To: Graeme Knox
From: Brett McClurg
Date: 23 June 2022
Subject: Yarrabilba Masterplan Community
Precinct 4E Application
Response to EDQ Information Request

At: Lendlease
At: SLR Consulting Australia Pty Ltd
Ref: 620.11743-M02-v0.3-20220623.docx

Approval no. DEV2022/1280

P04ROL4 FUNCTIONAL LAYOUT
ROADWORKS PLAN

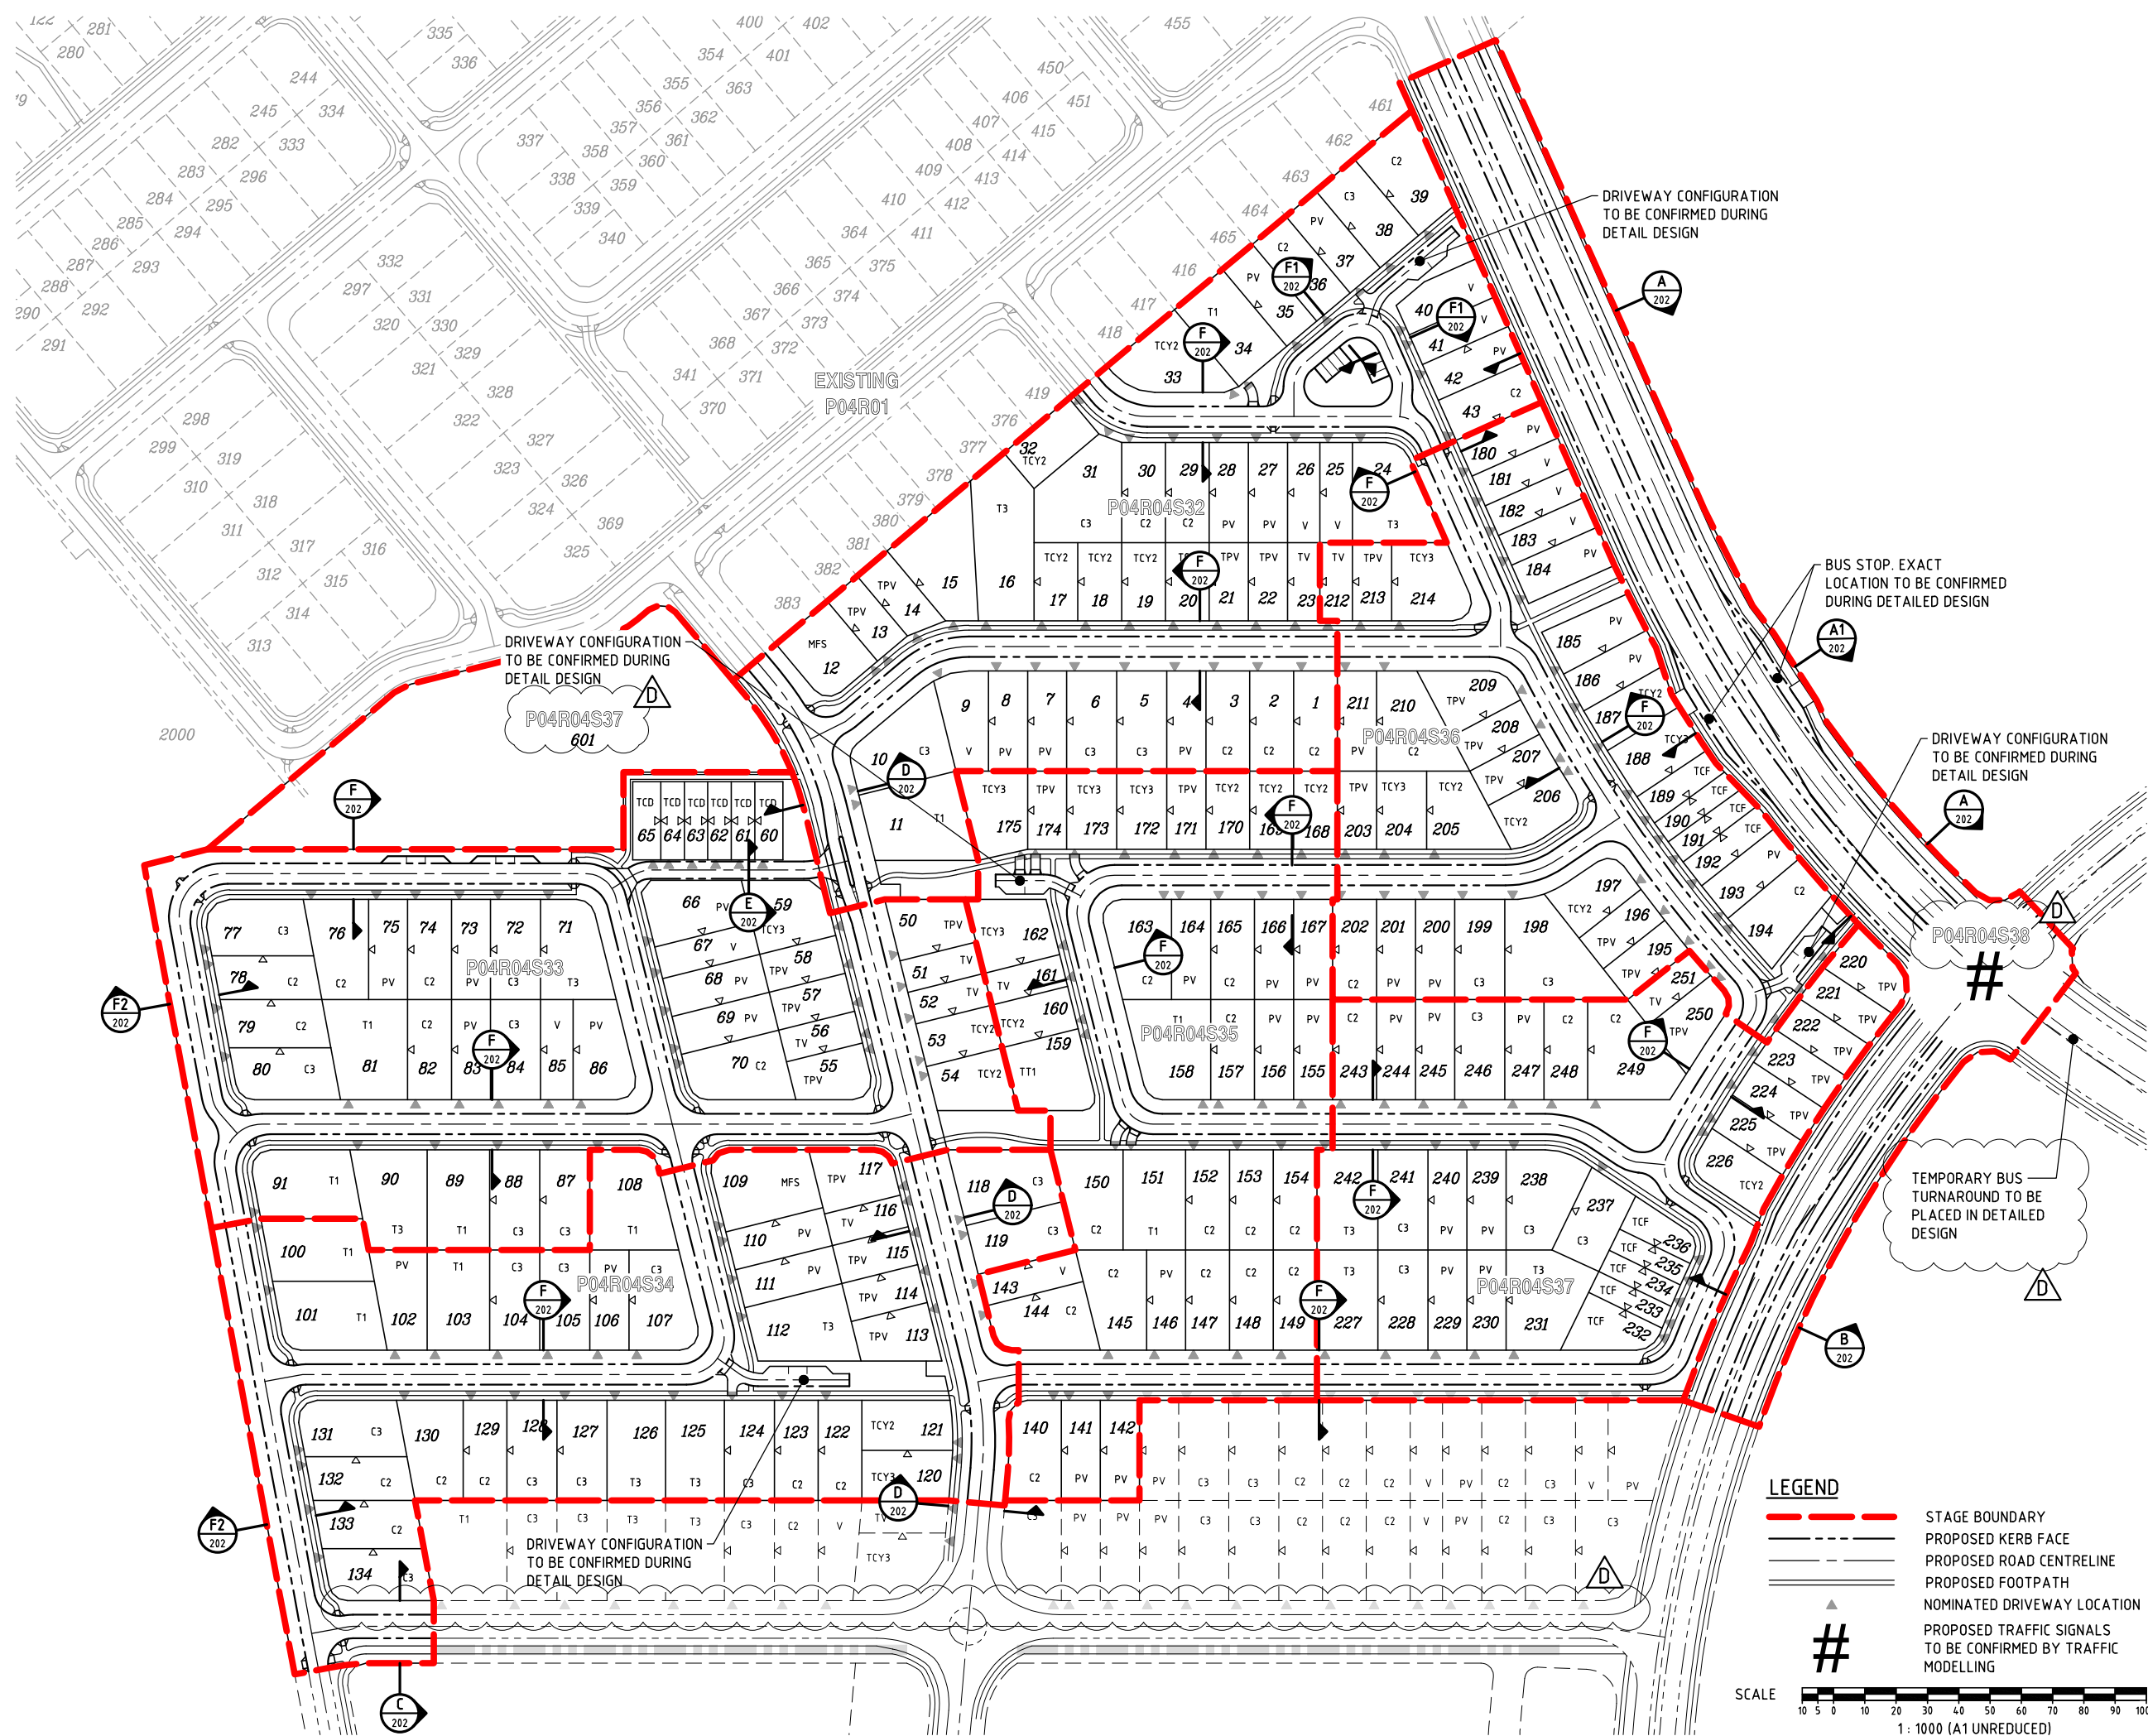
Issue: Amend the cross section of the “Local Collector with Greenway” (C/201) to meet the minimum required road width of 22m, and clearly mark the cross section C/201 on the road layout plan.

Issue: Amend cross F1/201 & F1/202 to meet the minimum required road width of 12m for the local access street adjoining the park.

Response: The subject road section was incorrectly labelled and has now been correctly labelled as ‘Local Street’ on the updated functional plans included at **Appendix C**.

The updated cross section is shown (on the updated functional plans) as 4.5m verge + 7.5m pavement + 8m verge = 20m reserve. This cross section will apply to the east-west street along the southern edge of P4E (see south-west corner of development plan. This road will have a two way daily traffic volume less than 500vpd.

Response: The subject road cross section is shown (on the updated functional plans) as 4.5m verge + 6.5m pavement = 11m reserve (the 90 degree parking indented is not shown on the cross section but is additional to the 11m reserve). This road will have a minimal volume, being less than 100vpd. The 90 degree car parking spaces are proposed within road reserve (additional to 11m) and the adjoining space is landscaping, not park, within that road reserve.
